**PLANNING COMMISSION MEETING
MUNICIPAL CENTER COUNCIL CHAMBERS
Tuesday, April 3, 2018**

5. The Shops of Saddle Creek South P.D, Outline Plan Amendment, and Revised Final Plan Approval

Company
Representative:	Lindsey Hearon w/Kimley-Horn
Zoning District:	“T5” Urban Center (utilizing the underlying SC-1 Zoning District)
Area:	2.00 acres
Request:	Outline Plan Amendment and Revised Final Plan Approval for a Parking Lot Expansion

CURRENTLY APPROVED SITE PLAN
 (ENLARGED COPY OF EXISTING CONDITION PLAN ARE INCLUDED WITH THIS REPORT)

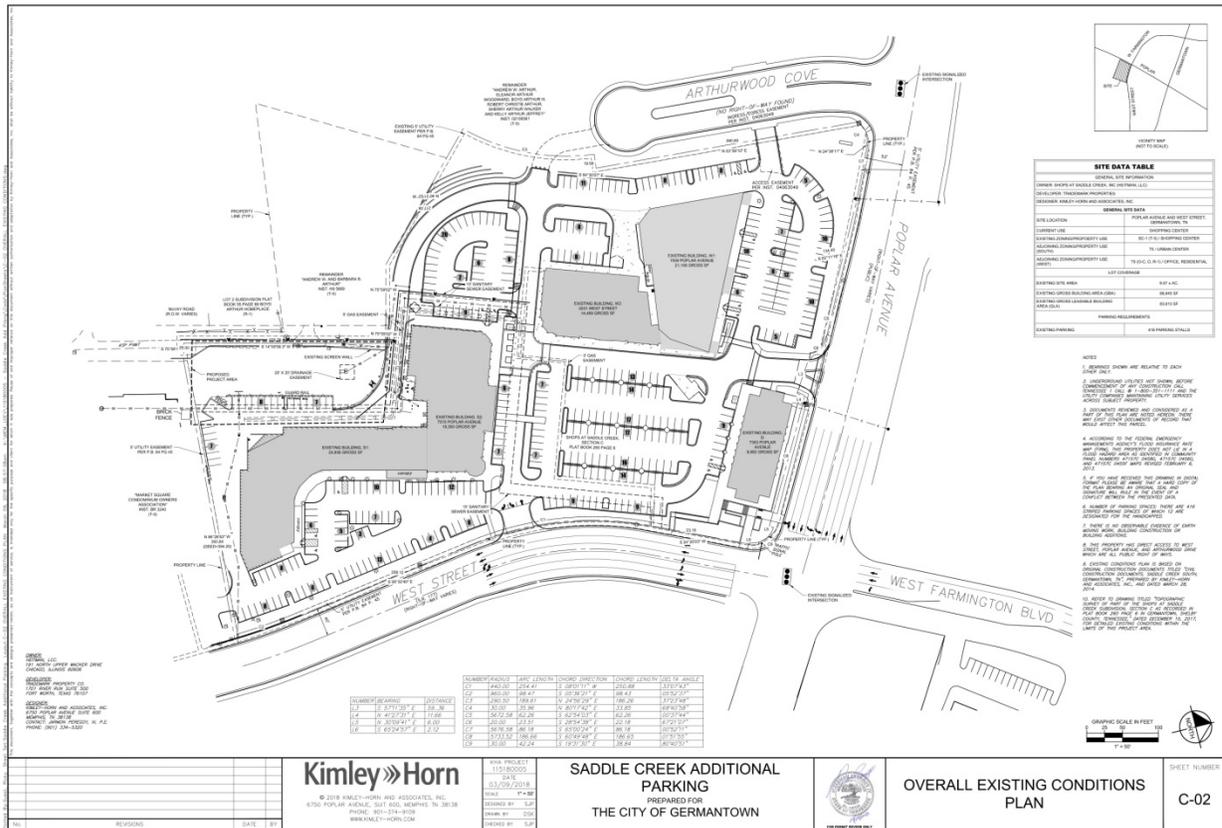
DISCUSSION: The current request is to revise the existing site plan to add 50 new parking spaces with the construction of a parking deck in the southwest corner of the site adjacent to the dead-end portion of McVay Road. The new parking would be for the exclusive use of employees and for valet parking. The approval of this parking lot expansion will bring the site into conformance with the parking standards required for the SC-1 District.

As part of this request, the applicant is seeking to reduce the minimum width of one drive aisle from a minimum of 24 feet wide to 20 feet wide, at the southern end of the proposed parking deck (See applicant letter on page 17). Traffic within this new parking deck will be one-way and the parking spaces along this reduce drive aisle will be angled to the travel lane. This configuration will reduce the likelihood of a conflict arising between vehicles backing out of the spaces and those that will be traveling through the drive aisle.

We are requesting an exception to the previously approved drive aisle widths for the Shops at Saddle Creek. In 2013, a 24-foot minimum and 26-foot maximum drive aisle width was approved and recorded. We propose a reduction of the drive aisle to 20' for one-way traffic within the parking deck.

This is required due to the existing limitations within the area of the proposed project. The entrance is constrained by the proposed retaining wall location for the parking deck and the existing transformer that will remain in place. The location of the retaining wall was positioned to avoid the existing screen wall on the west side of the property as well as to achieve the 18' parking stall length. The existing transformer will remain in place to avoid disrupting electric service to the shopping center. The exit is also constrained by an additional existing transformer and three (3) proposed angled parking stalls. The angled parking stalls were provided to maximize parking for the project and for the development. The parking stalls could not be shifted south due to property line constraints.
